Pre-Application Briefing to Committee

Reference No: PPA/2024/0002

Address: 157-159 Hornsey Park Road, N8 0JX

Report of Chair's Review Meeting: 157-159 Hornsey Park Road

Landscaping/ground floor plan

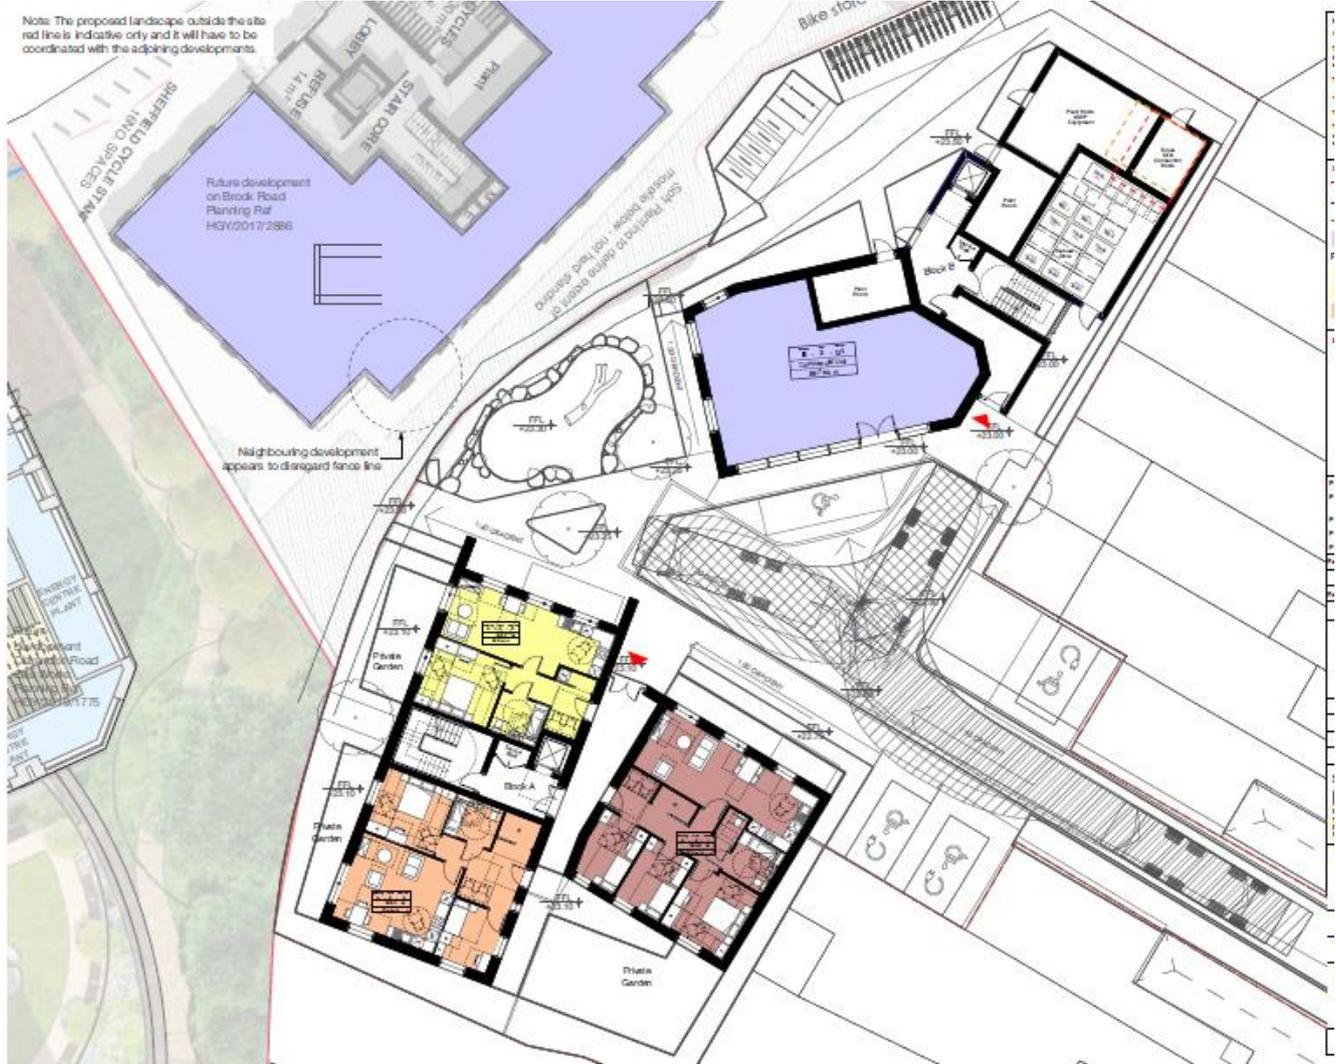
- The landscape plan is currently too loose to show which areas are public, private, or semi-private, and which are for vehicles or for pedestrians. The landscaping must be developed to a much finer level of detail to show how spaces will be defined, alongside a realistic management strategy for maintaining the proposed spaces.

- The landscape plan should carefully consider and define how changes in surface materials and boundary treatments (such as low brick walls, railings and planting) can be used to clarify the nature of different space types for occupants and for visitors.

- The panel is particularly concerned about the lack of separation between vehicles and pedestrians. There should be clear demarcation, including areas for loading and unloading deliveries, to ensure that the site does not fill up with commercial vehicles, detracting from the landscaping.

- The panel suggests that vehicles should only be allowed into the site as far as the western corner of the commercial block, with a clear stop and a turning head here. The public realm beyond this point can then be more pedestrian friendly, including softer, greener landscaping for the residents.

- The panel is not convinced by the circular plant room building (drum) in the centre of the public realm. Although the development will be gated at night, its location and design allow for unobserved loitering.

- This could enable antisocial behaviour and encourage people to try to break into the nearby cycle store. If the drum was removed, both the external route to the cycle store and to the residential Block A entrance from the northwest would be better overlooked.

- Due to the possibility of unobserved loitering immediately behind, the panel does not think it appropriate to have play space next to the drum. However, if it were to be removed, the area could accommodate a larger, more pleasant play space that would be overlooked, south-facing, and easier to manage.
